Shenzhen Soruida Electronics Co., LTD	File number	SRD-WI-18465	Issue date	2023-08-17
	edition	A1	Effective date	2023-08-17
STX.505310.10T02 Sample acknowledgement	Number of revisions	1	Page code	1 / 3

editi on	Change the calendar ...		Alteration party	Change time
A	New issue: February 18, 2023		Tang Yangying	2023-02-18
A1	Before change	After the change	Mo Chenghui	2023-08-17
	1. Line length H size: 15.0±2.0 2. High-temperature tape: 6MM 3. Double-sided tape should be attached to the magnetic disc	1. Line length H size: 10.0±2.0 2. High-temperature tape: 3MM 3. Cancel the adhesive backing on the coil surface of the magnetic disc

1. Dimensions: (Unit: mm)

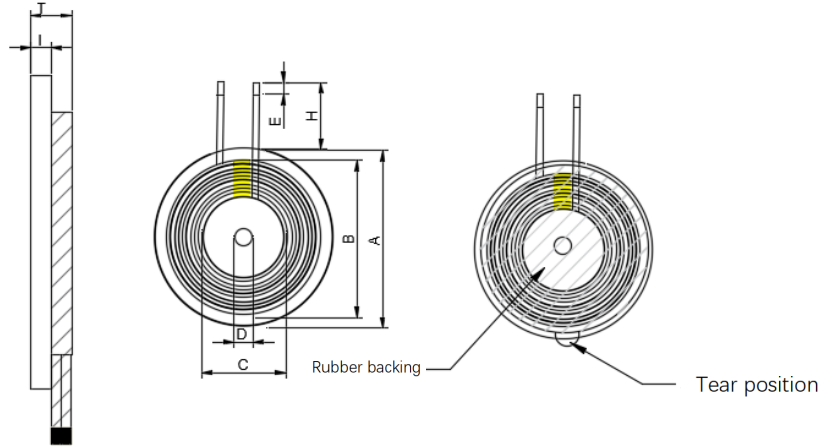
Note:	Modification record:
1: Wrap 3MM (ref) high-temperature adhesive paper around the coil outlet position	1.
2: The back of the magnetic disc should be glued, with hand tear	2:

Note: Wrap 3MM (ref) high temperature adhesive paper around coil outlet position
